**Erratum: “Thermomigration in flip-chip SnPb solder joints under alternate current stressing” [Appl. Phys. Lett.90, 152105 (2007)]**

Hsiang-Yao Hsiao and Chih Chen

Citation: [Applied Physics Letters](#) **90**, 249902 (2007); doi: 10.1063/1.2748851

FIG. 3. The measured temperature increases in the bump as a function of applied current and current densities.

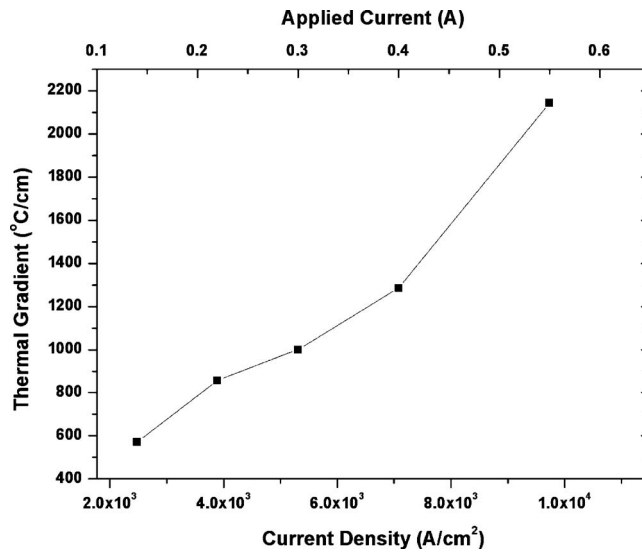
The applied current densities were wrongly calculated. The revised Fig. 3 with correct current densities is shown below. In addition, the value of “ $9.2 \times 10^4$  A/cm<sup>2</sup>” in the abstract, on p. 152105, and in figure caption of Fig. 2(b) should be modified as “ $9.7 \times 10^3$  A/cm<sup>2</sup>.” The value of “ $5 \times 10^4$  A/cm<sup>2</sup>” on p. 152105 should be revised as “ $5.3 \times 10^3$  A/cm<sup>2</sup>.” These corrections do not affect any other part of the article and the conclusions.
